Re: Proposed Tewar Landfill, Rush Township,  
Centre County, Pennsylvania  
ARM Project 04117

The purpose of this correspondence is to request input from the Bureau of Watershed Management regarding certain Pennsylvania Department of Environmental Protection (PADEP) application questions pertaining to a proposed new landfill facility. Attached are United States Geologic Survey (USGS) 7.5-minute topographic quadrangle maps displaying the location of the proposed facility.

Re: Proposed Tewar Landfill, Rush Township  
Centre County, PA; ARM Project 04117

Proposed Footprint - Tewar Landfill		
Resource Recovery, LLC Rush Township Centre County, Pa.		
July 2004	Scale 1"=2000'	04117
	<b>ARM Group Inc.</b> Earth Resource Engineers and Consultants 1129 Wolf Creek Road - Hanbury, PA 17033-0791 (717) 533-8600 Fax: (717) 533-8605	Figure 1A

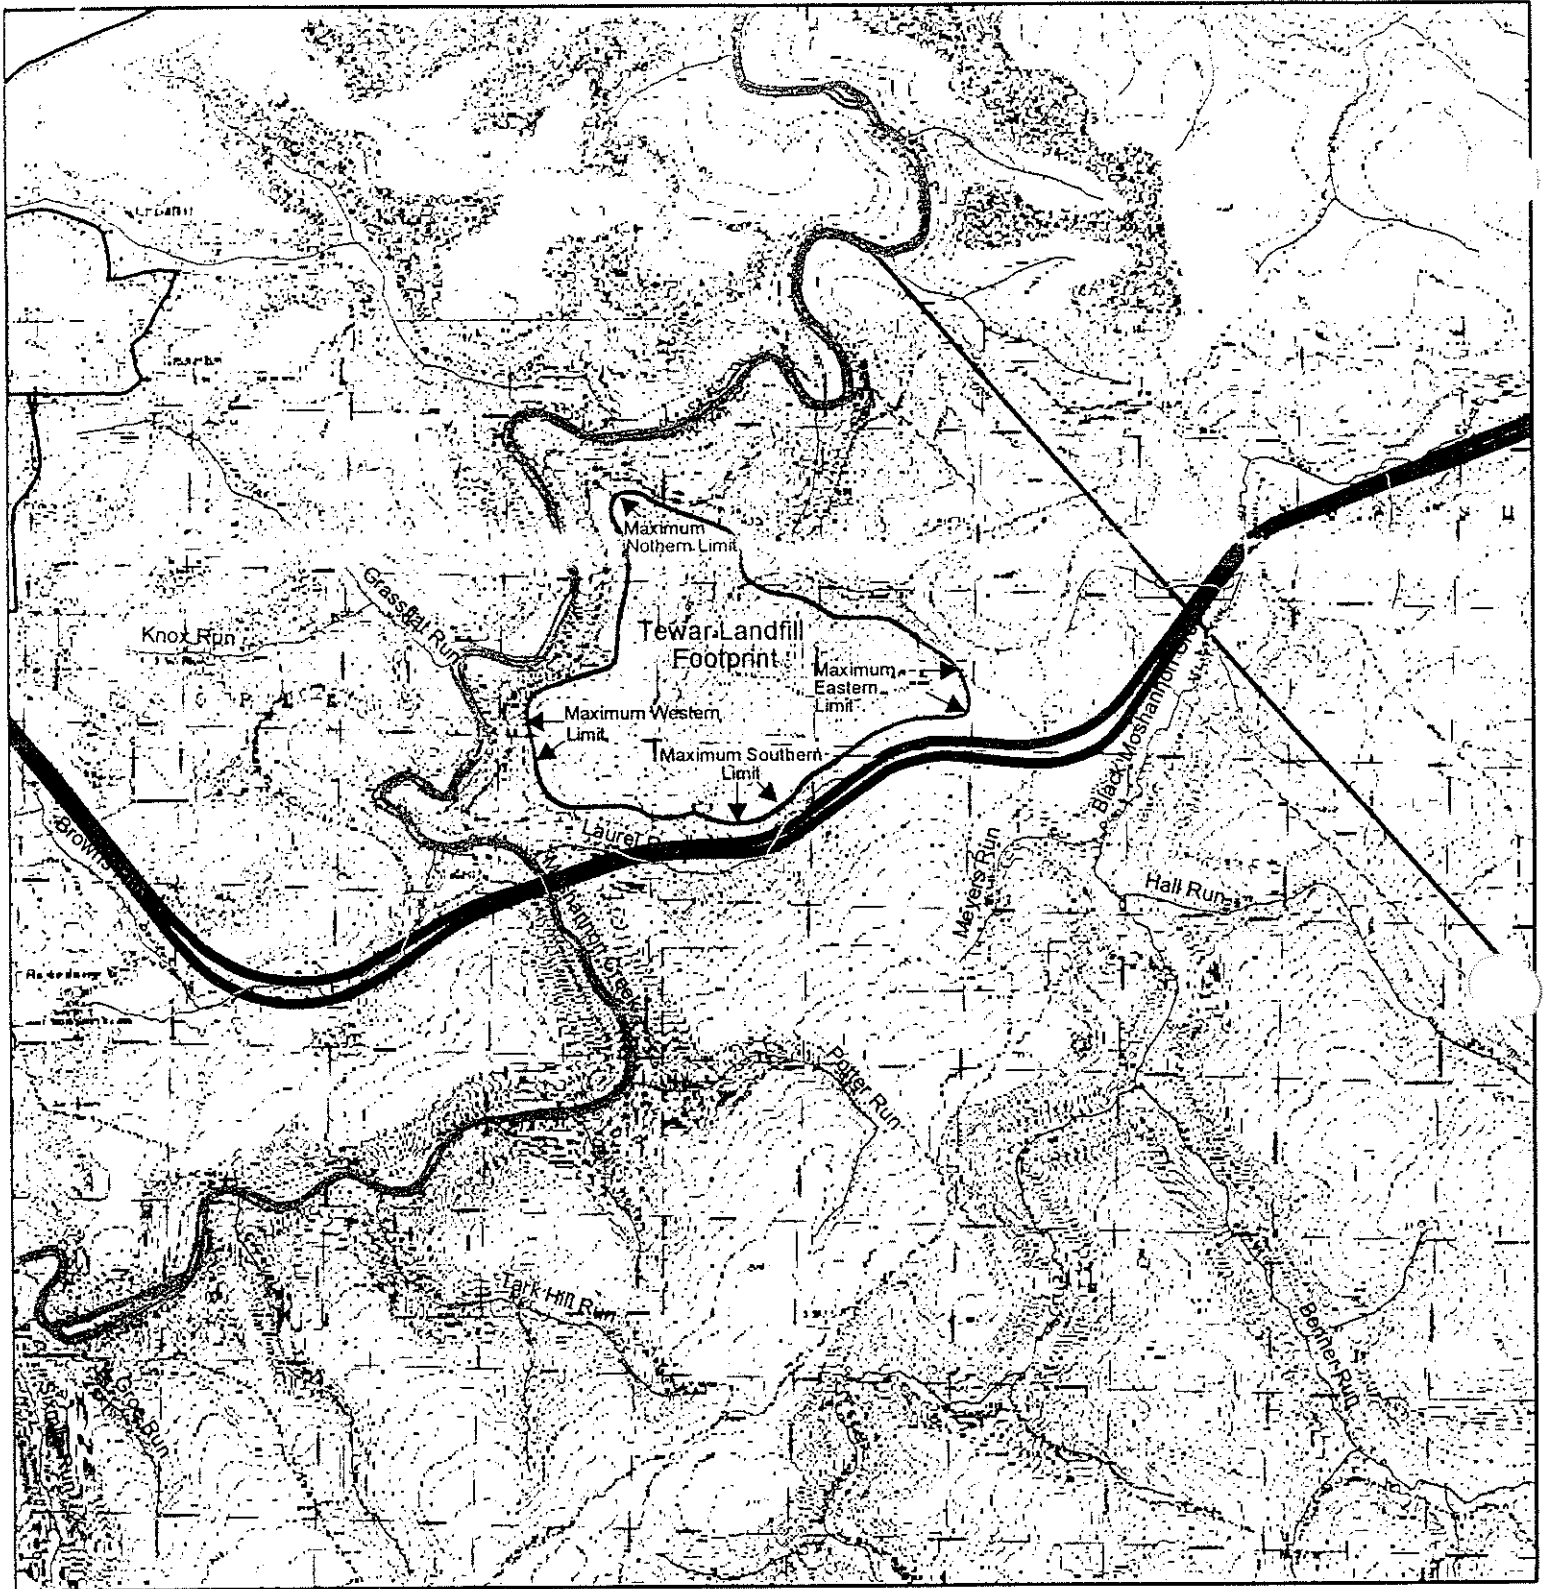
Your July 14, 2004 inquiry to Stuart Gansell, Director of the Bureau of Watershed Management, regarding a proposed landfill facility in Rush Township, Centre County has been forwarded to me. A map review of the area indicates that the Moshannon Creek, its Laurel Run tributary, and an unnamed tributary provide surface drainage for the area to be affected by your project.

Your first four bullet questions ask if your project is located in any corridor or waterway that is part of the Pennsylvania Scenic River or National Wild and Scenic River Systems or under consideration for inclusion in these river protection programs. A cursory review indicates that no part of your project is applicable to these state and federal river programs. However, the Pennsylvania Scenic River Program is administered by the Department of Conservation and Natural Resources (DCNR) and these inquiries should be directed to them. The DCNR can also advise you of any rivers that are part of the National Wild and Scenic River System. Their address is:

<b>Proposed Footprint - Tewar Landfill</b>		
Resource Recovery, LLC Rush Township Centre County, Pa.		
July 2004	Scale 1"=4000'	04117
	<b>ARM Group Inc.</b> Earth Resource Engineers and Consultants 1129 West Commerce Road - Hazleton, PA 17833-0797 (717) 533-6600 Fax (717) 533-6602	<b>Figure</b> 1B

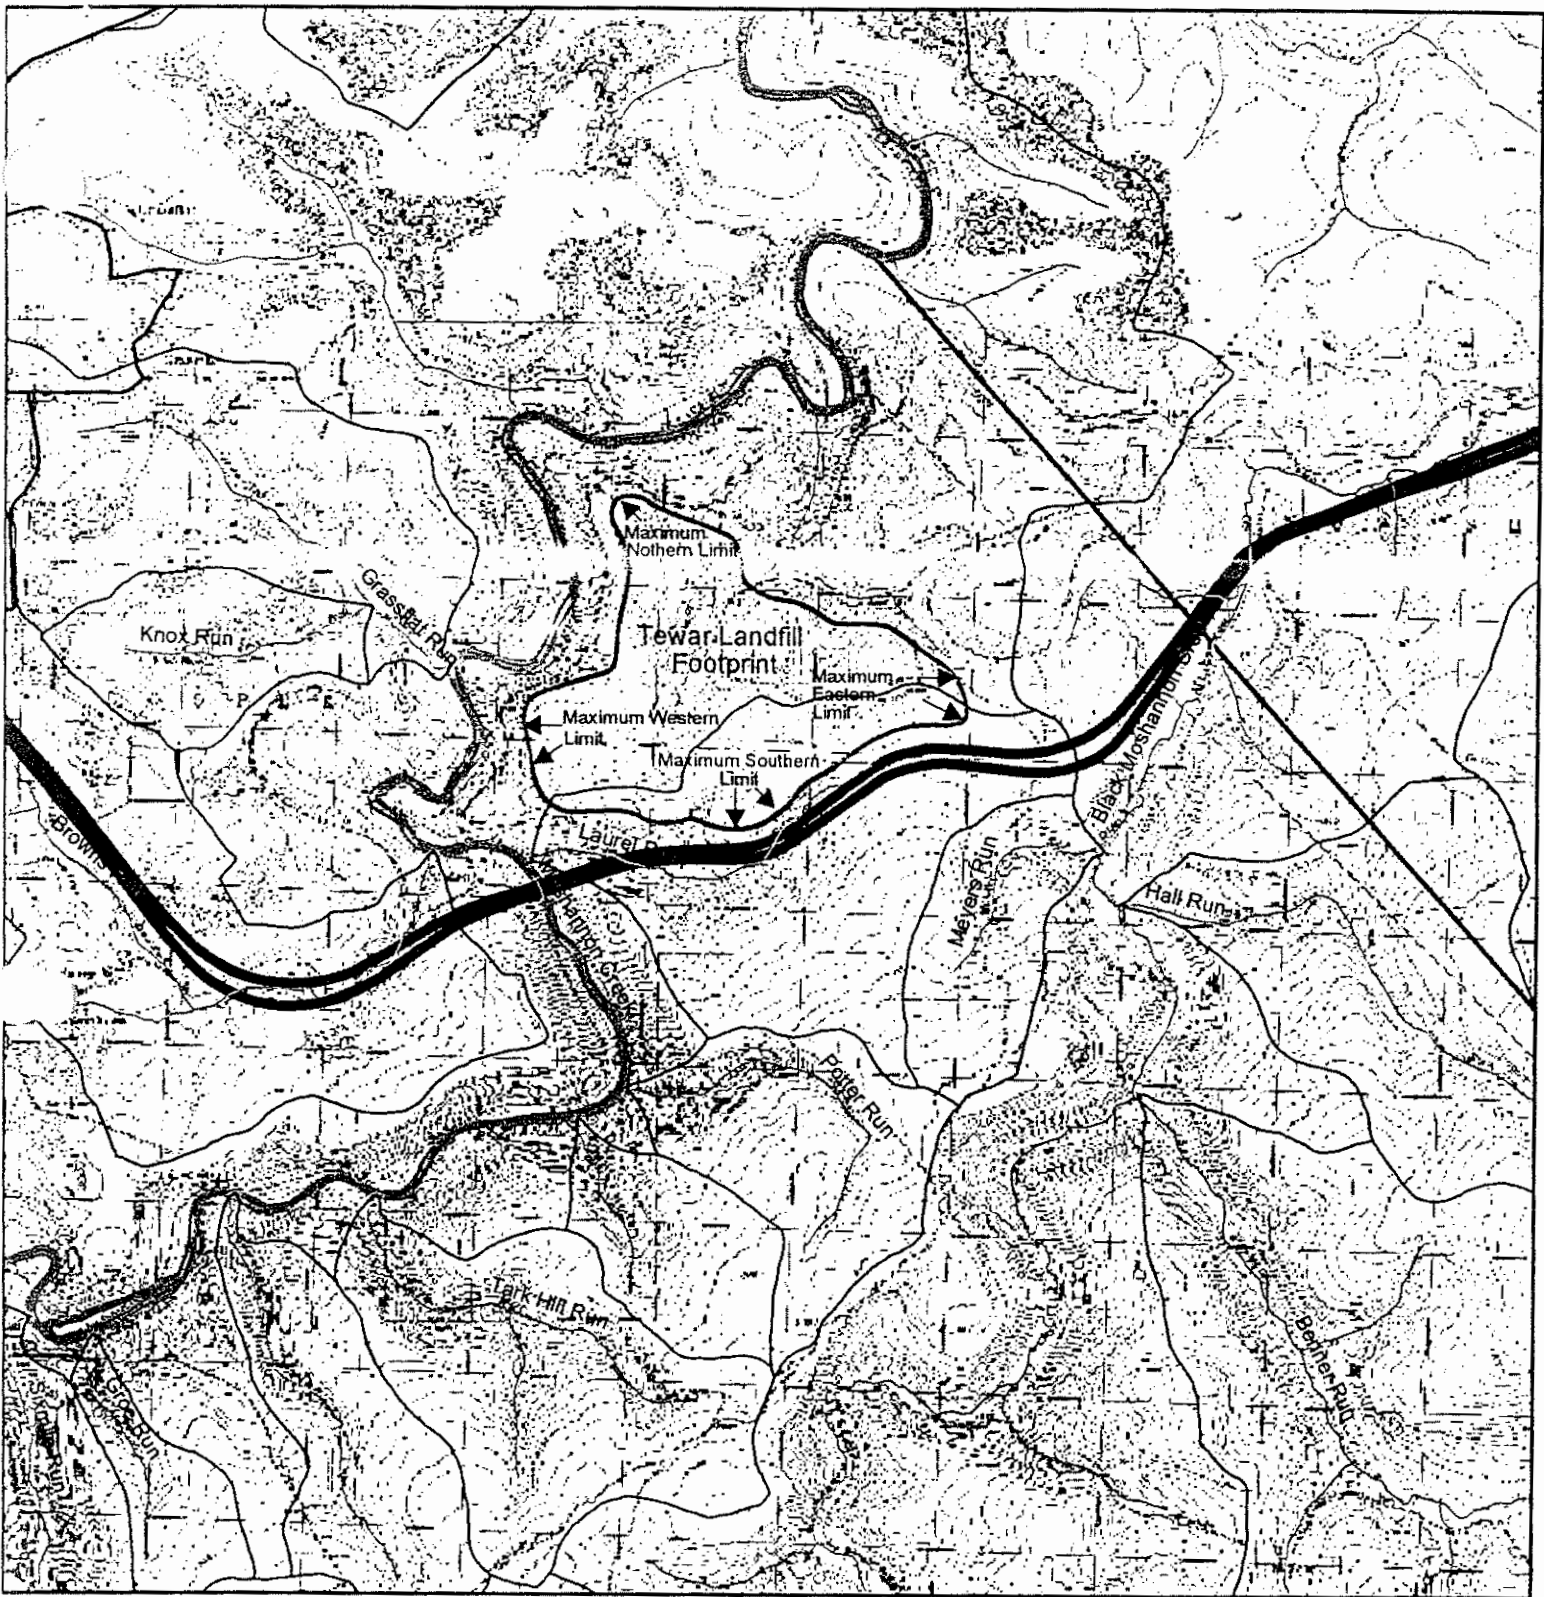
Regarding your last bullet question inquiring about the "Special Protection Watershed" status of your project's receiving streams, they are not subject to Chapter 93 rules and regulations that would assign them Antidegradation protection (previously referred to as "Special Protection Watersheds"). Rather, these receiving streams are classified as Cold Water Fishes (CWF). However, be advised that the portion of the Black Moshannon Creek watershed adjacent

to the "maximum eastern limit" of your project is classified as an Antidegradation (High Quality – Cold water Fishes) watershed.
